Model: Perfect Binder GB5000	Date: 20-June -08	No.: RD391001a
-------------------------------------	-------------------	----------------

Subject: Firmware Release Note: P-Binder_B1		Prepared by: T.Tadokoro	
From: PPBG QA/Service Planning Dept.			
Classification:	<input type="checkbox"/> Troubleshooting	<input type="checkbox"/> Part information	<input type="checkbox"/> Action required
	<input type="checkbox"/> Mechanical	<input type="checkbox"/> Electrical	<input type="checkbox"/> Service manual revision
	<input type="checkbox"/> Paper path	<input type="checkbox"/> Transmit/receive	<input type="checkbox"/> Retrofit information
	<input checked="" type="checkbox"/> Other ()

Subject: STAY: Parts catalog correction		Prepared by: T. Tadokoro	
From: PPBG QA/Service Planning Dept.			
Classification:	<input type="checkbox"/> Troubleshooting <input type="checkbox"/> Mechanical <input type="checkbox"/> Paper path <input type="checkbox"/> Other ()	<input checked="" type="checkbox"/> Part information <input type="checkbox"/> Electrical <input type="checkbox"/> Transmit/receive	<input type="checkbox"/> Action required <input type="checkbox"/> Service manual revision <input type="checkbox"/> Re

8.Inserter Section 2 (D391)

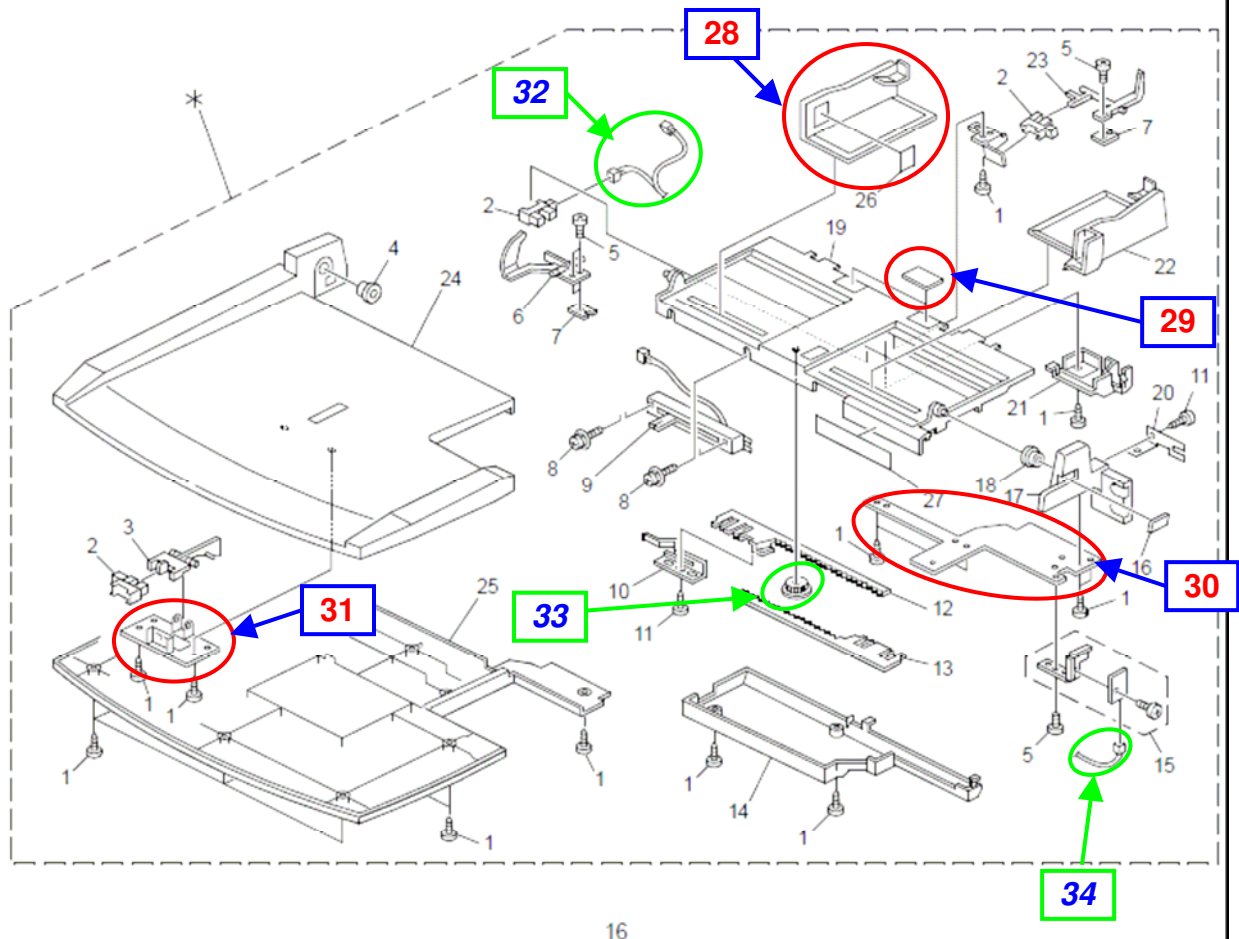
New Part Number	Description	Q'ty	Int	Page	Index	Note
D3914118	Side Fence:Tray:Upper:PF3099P023	1	-	16	28	Add
D3914119	Friction Pad:Pickup:PF3091P327	1	-	16	29	Add
D3914121	Frame:Tray:PF3091P120	1	-	16	30	Add
D3914125	Holder:Sensor:PF3091P045	1	-	16	31	Add
D3914117	HARNESS:TRAY:UPPER:PF3099K911	1	-	16	32	Add
D3914124	GEAR:PINION:TRAY:PF3091P053	1	-	16	33	Add
D3914122	HARNESS: DESIGN SKETCH: LED: PF3091K320	1	-	16	34	Add

Part Number	Incorrect Description	Correct Description	Q'ty	Int	Page	Index
D3914026	Tray Unit: Upper: PF3091K152A:Ass'y	Tray Unit: Upper: PF3099K152:Ass'y	1	-	16	*
D3914061	Lever:PF3091P046A	Lever:PF3099P046	1	-	16	3
D3914063	Lever:PF3091P048A	Lever:PF3099P048	1	-	16	6
D3914046	Cover:Tray:Upper Lower: PF3091P021A	Cover:Tray:Upper Lower: PF3099P021	1	-	16	14
D3914044	Tray:Base:Sub:PF3091P015A	Tray:Base:Sub:PF3099P015	1	-	16	17
D3914021	Tray:Upper Lower:Bin: Upper: PF3091K102A	Tray:Upper Lower:Bin:Upper: PF3099K102	1	-	16	19
D3914047	Guide:Tray:Upper:Front: PF3091P022A	Guide:Tray:Upper:Front: PF3099P022	1	-	16	22

9.Inserter Section 3 (D391)

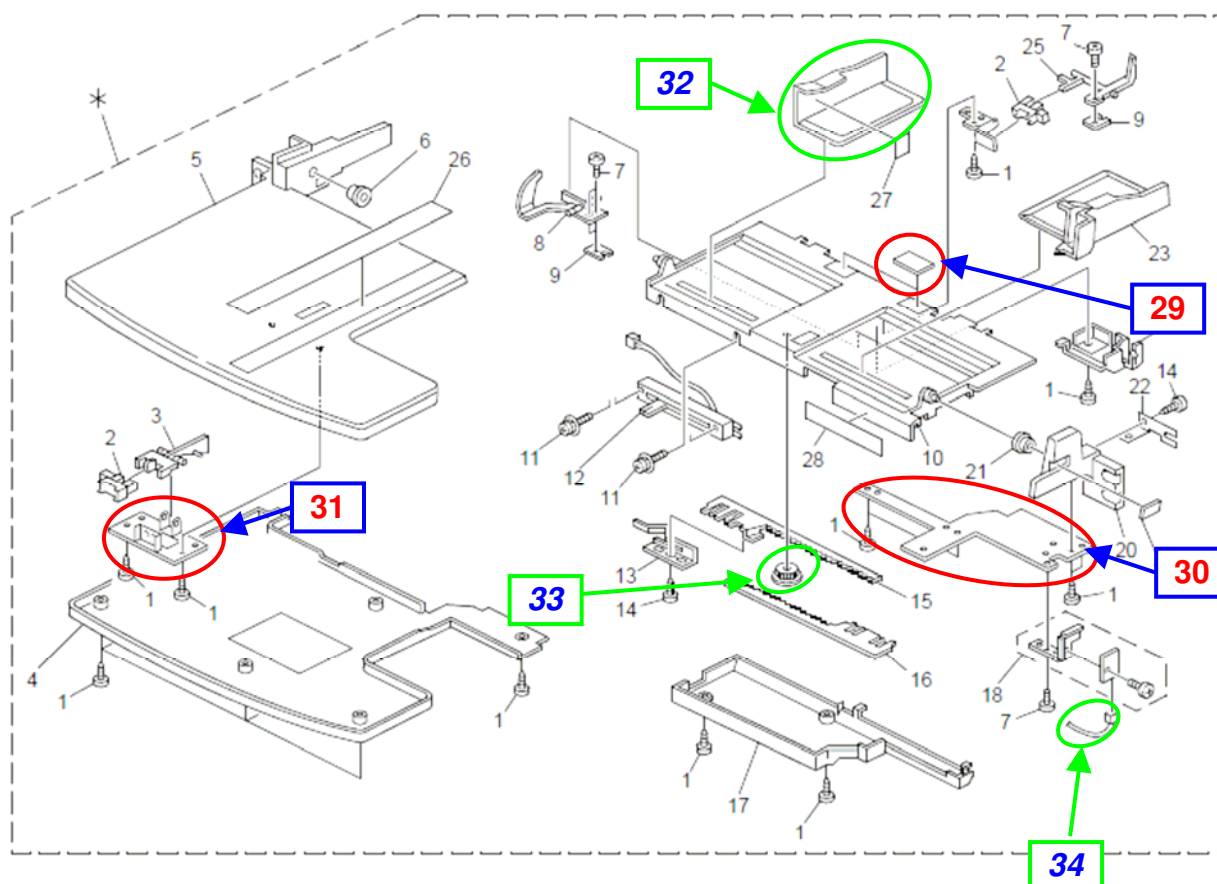
New Part Number	Description	Q'ty	Int	Page	Index	Note
D3914119	Friction Pad:Pickup:PF3091P327	1	-	18	29	Add
D3914121	Frame:Tray:PF3091P120	1	-	18	30	Add
D3914125	Holder:Sensor:PF3091P045	1	-	18	31	Add
D3914126	SIDE FENCE:TRAY:LOWER:PF3099P025	1	-	18	32	Add
D3914124	GEAR:PINION:TRAY:PF3091P053	1	-	18	33	Add
D3914130	HARNESS:BIN DISPLAY:PF3091K326	1	-	18	34	Add

Part Number	Incorrect Description	Correct Description	Q'ty	Int	Page	Index
D3914025	Tray Unit: Lower: PF3091K144A:Ass'y	Tray Unit: Lower: PF3099K144:Ass'y	1	-	18	*
D3914045	Cover:Tray:Lower: PF3091P017A	Cover:Tray:Lower: PF3099P017	1	-	18	4
D3914033	Base:Tray:Lower:PF3091P014A	Base:Tray:Lower: PF3099P014	1	-	18	5
D3914063	Lever:PF3091P048A	Lever:PF3099P048	1	-	18	8
D3914044	Tray:Base:Sub:PF3091P015A	Tray:Base:Sub:PF3099P015	1	-	18	20
D3914048	Guide:Tray:Lower:Front: PF3091P024A	Guide:Tray:Lower:Front: PF3099P024	1	-	18	23
D3914022	TRAY:UPPER LOWER: BIN: LOWER: PF3091K103A	TRAY:UPPER LOWER: BIN: LOWER: PF3099K103A	1	-	18	10

10.Inserter Section 4 (D391)

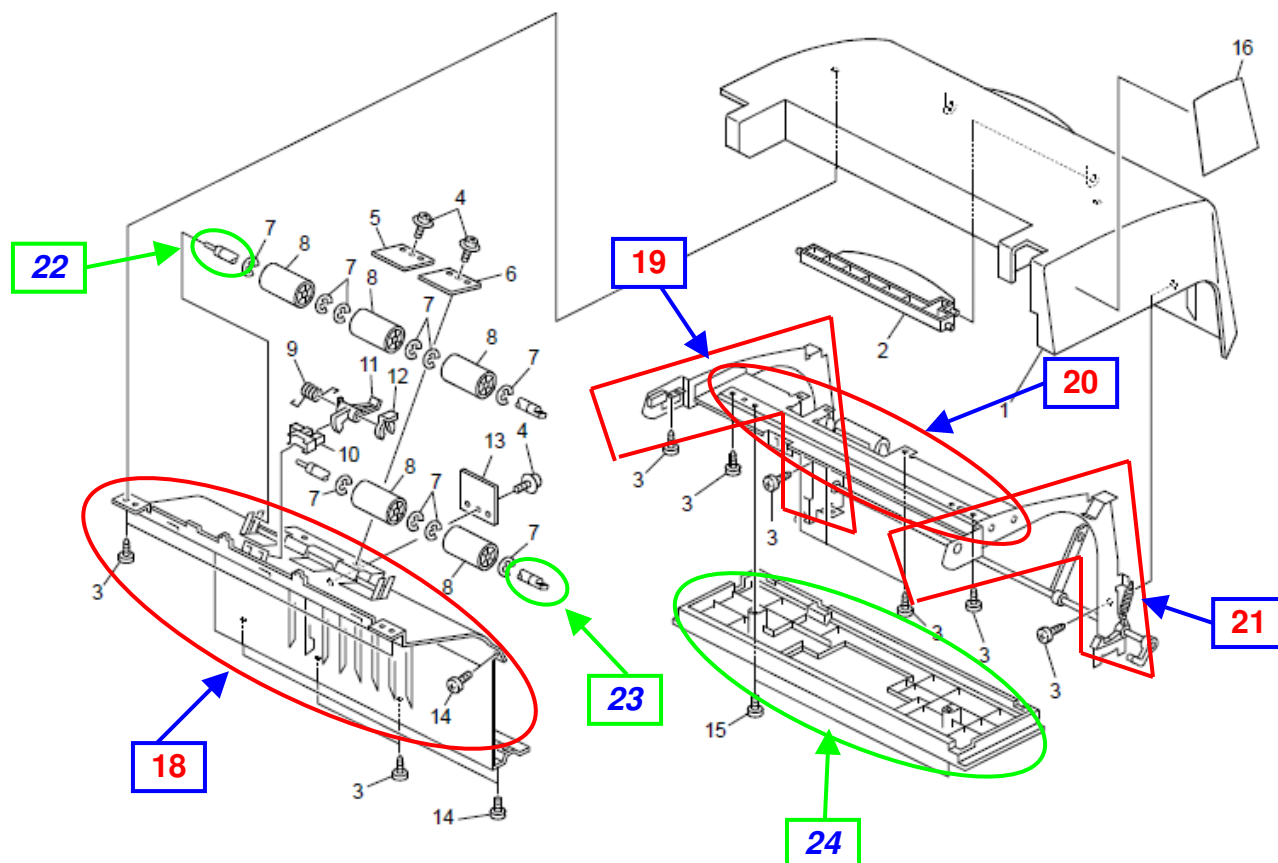
New Part Number	Description	Q'ty	Int	Page	Index	Note
D3914136	Guide:Bin:Upper:PF3091P111	1	-	20	18	Add
D3914137	Side Plate:Cover:Rear:PF3091P109	1	-	20	19	Add
D3914138	Stay:Cover:Upper:PF3091P110	1	-	20	20	Add
D3914139	Side Plate:Cover:Front:PF3091P108	1	-	20	21	Add
D3914134	SHAFT:REGISTRATION ROLLER: PF3091P213	1	-	20	22	Add
D3914135	SHAFT:TRANSPORT ROLLER:PF3091P214	1	-	20	23	Add
D3914140	GUIDE:PICKUP:PF3091P007	1	-	20	24	Add

Part Number	Incorrect Description	Correct Description	Q'ty	Int	Page	Index
D3914032	Cover:Upper:PF3091P004A	Cover:Upper:PF3099P004	1	-	20	1
D3914052	Lever:Open And Close:Cover: Upper: PF3091P029A	Lever:Open And Close:Cover: Upper: PF3099P029	1	-	20	2

31.Signature Delivery Section 5 (D391)

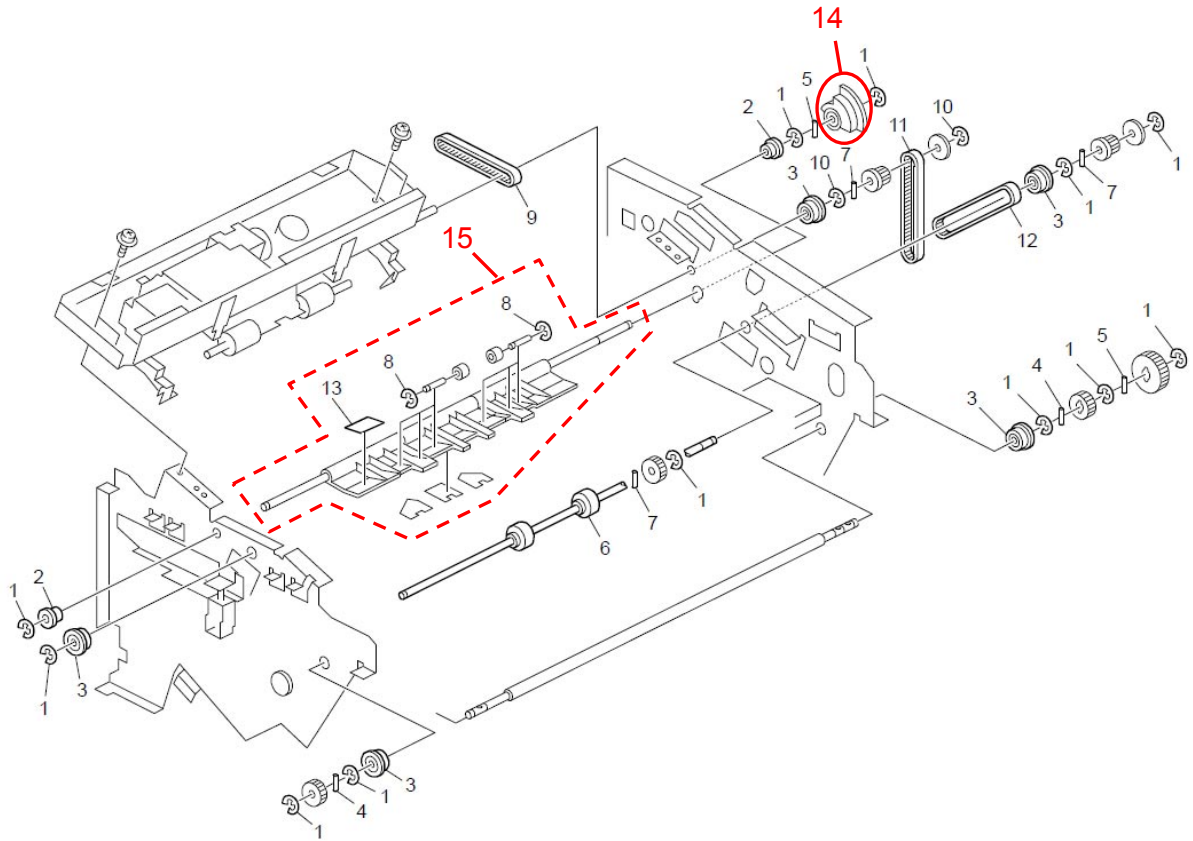
New part number	Description	Q'ty	Int	Page	Index	Note
D3911504	Gear:Switchback:PF4140P201A2	1	-	63	14	Add
D3911508	Vibrating Plate:Tray:PF4155L105:Ass'y	1	-	63	15	Add

39.Sub Gripper Section 2 (D391)

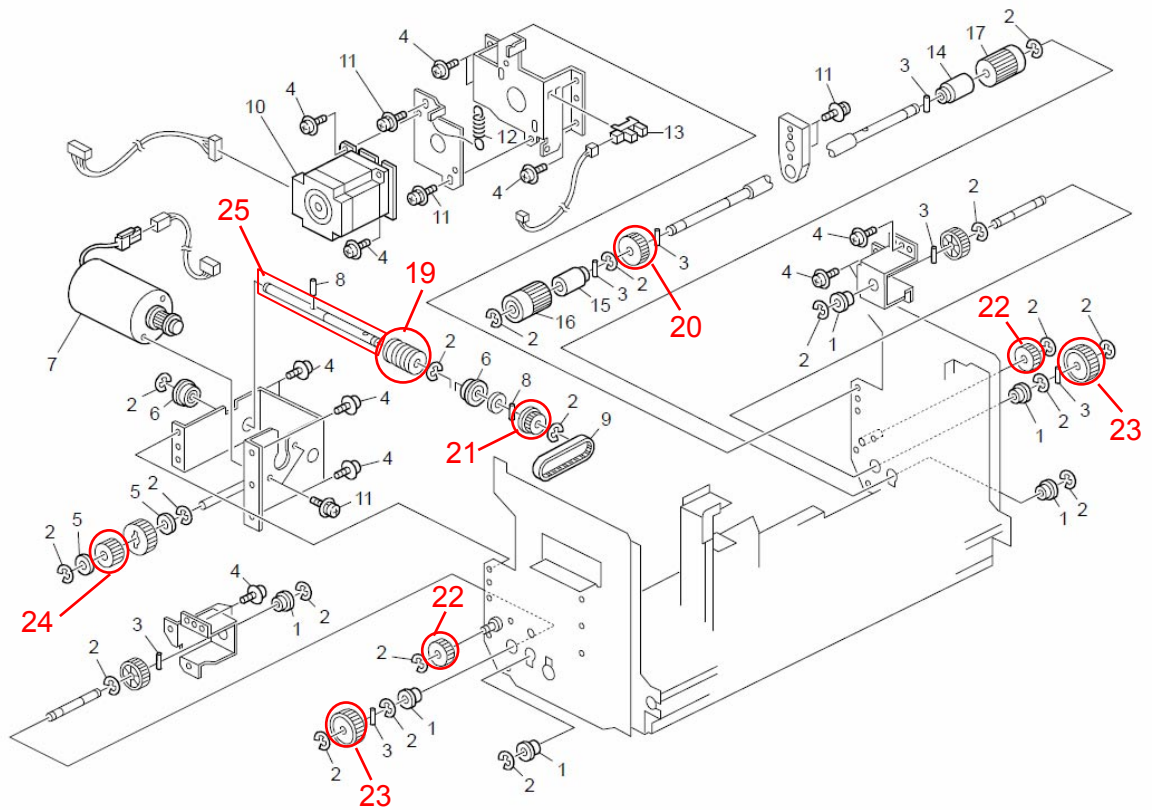
New part number	Description	Q'ty	Int	Page	Index	Note
D3911490	Gear:Worm Gear:100:PF4140P484A2	1	-	79	19	Add
D3911491	Gear:Z24:PF4140P387A	1	-	79	20	Add
D3911492	Pulley:T18:PF4140P998A	1	-	79	21	Add
D3911493	Gear:Grip:Main:PF4140P406A1	2	-	79	22	Add
D3911494	Gear:Z30:PF4140P996A	2	-	79	23	Add
D3911496	Gear:100-20-30:PF4140P488B2	1	-	79	24	Add
D3911503	Shaft:Gear:Worm Gear:PF4140P388	1	-	79	25	Add

41.Sub Gripper Section 4 (D391)

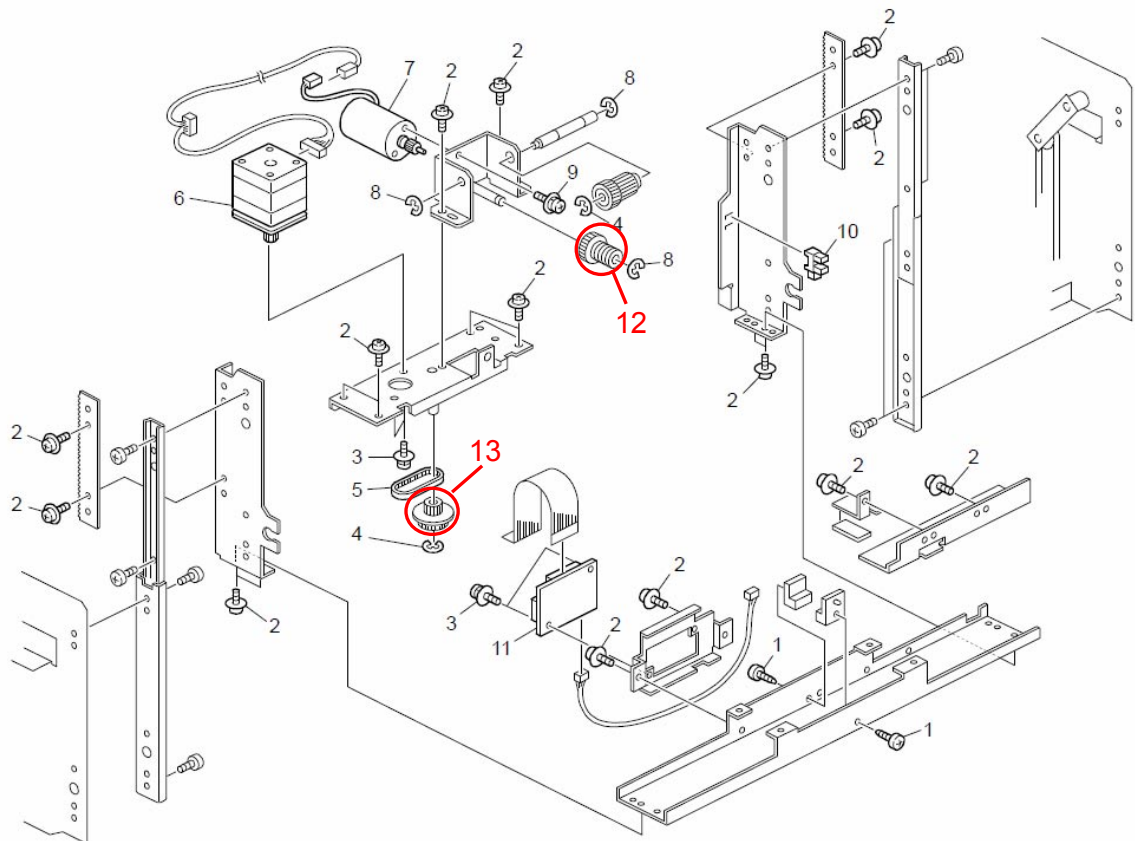
New part number	Description	Q'ty	Int	Page	Index	Note
D3911497	Gear:Worm Gear:PF4140P383A2	1	-	83	12	Add
D3911498	Pulley:T20:PF4140P338A1	1	-	83	13	Add

81.Stack Rotation Section 6 (D391)

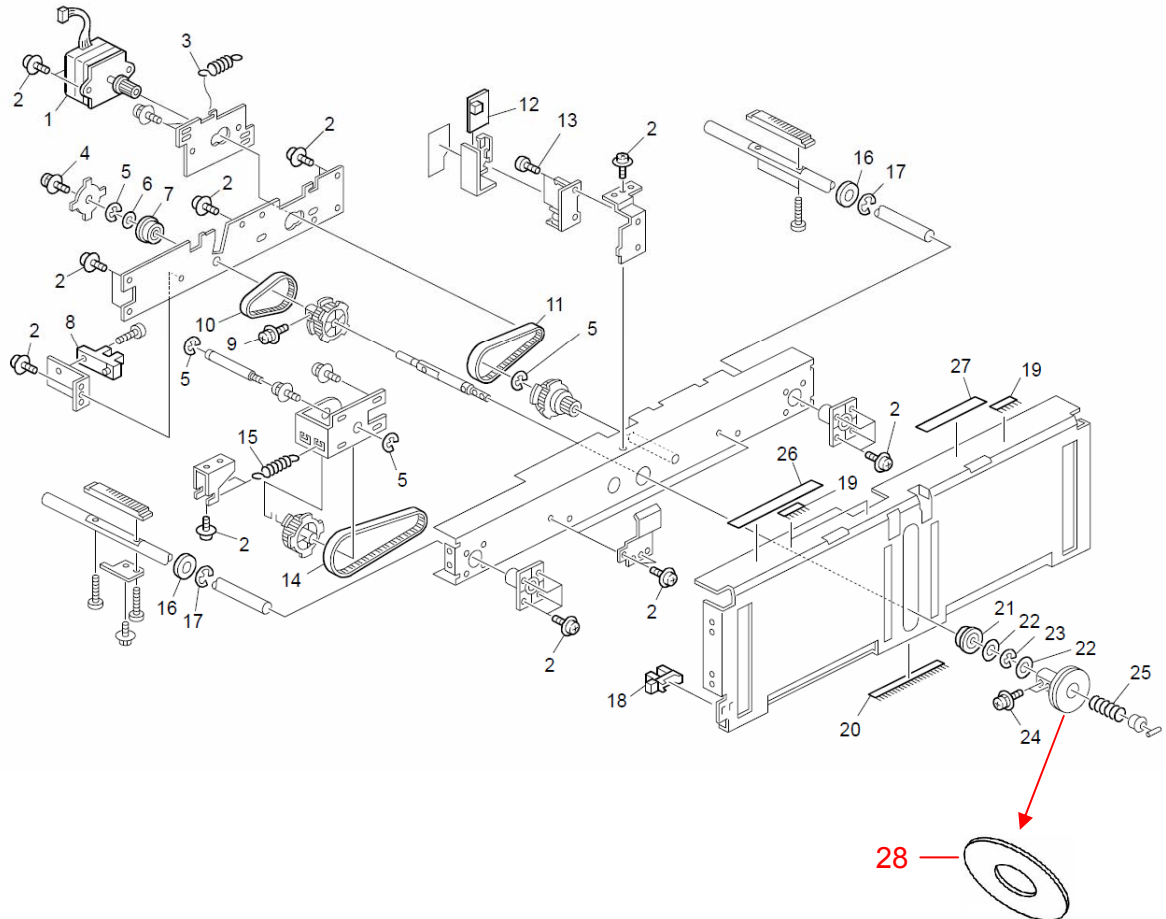
New part number	Description	Q'ty	Int	Page	Index	Note
D3911481	Sheet:Turn:PF4140Q204	1	-	163	28	Add

93.Electrical Section 2 (D391)

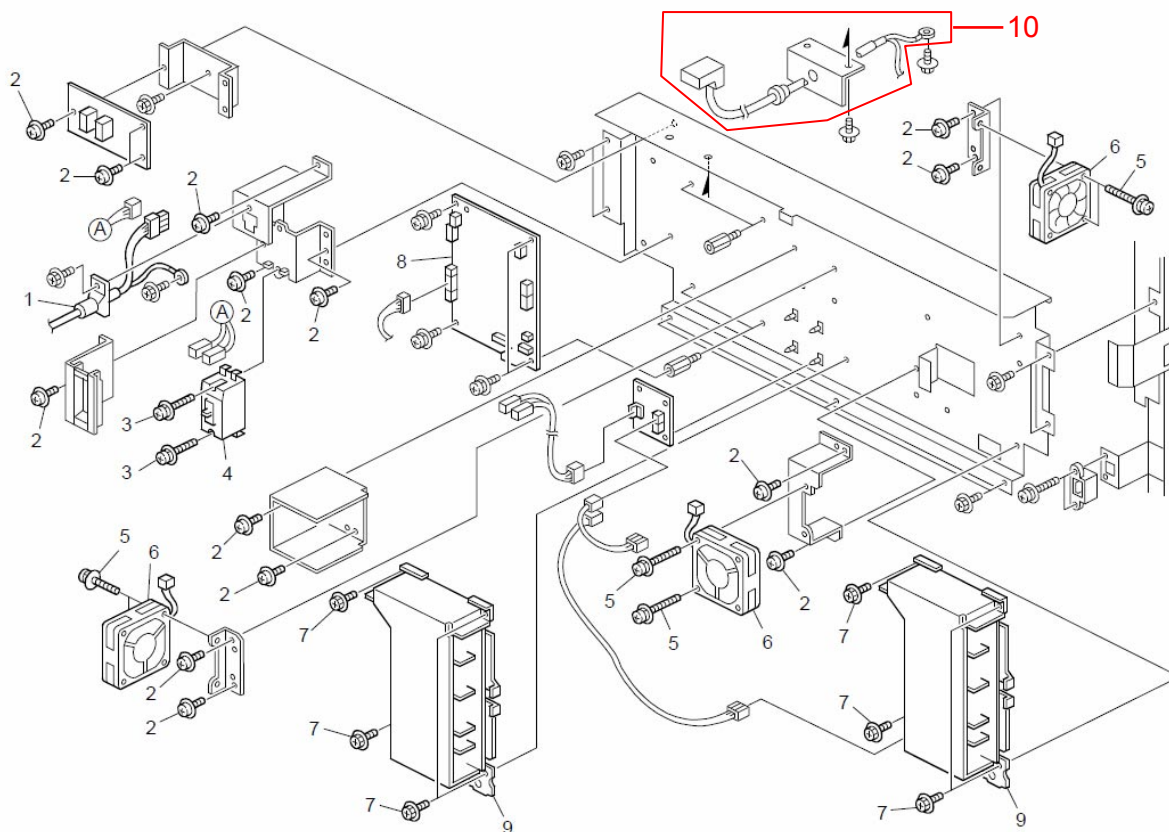
New part number	Description	Q'ty	Int	Page	Index	Note
D3915311	Interface Cable:Inner Assembly:PF4155K201	1	-	187	10	Add

41.Sub Gripper Section 4 (D391)

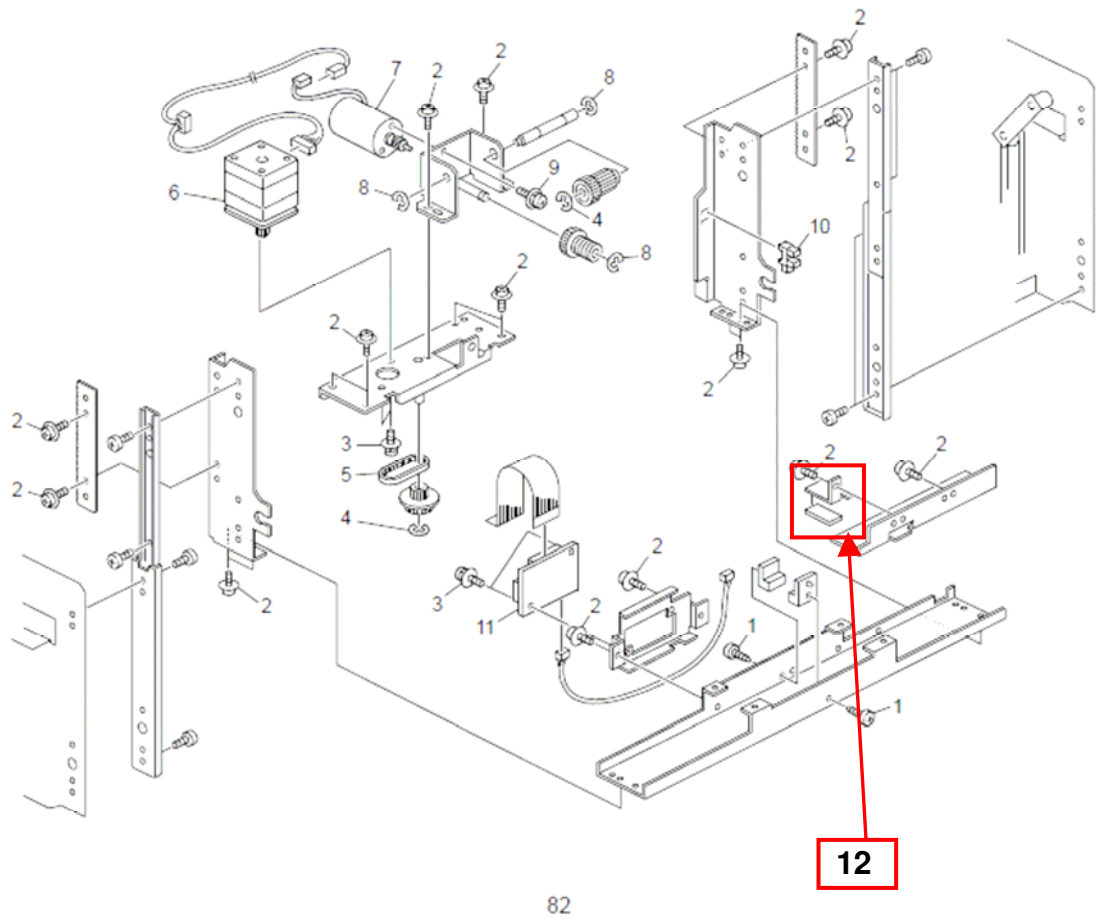
Part Number	Description	Q'ty	Page	Index	Note
D3911509	BRACKET: PLATE: CAVITY: PF4140K084A: ASS'Y	1	82	12	Add
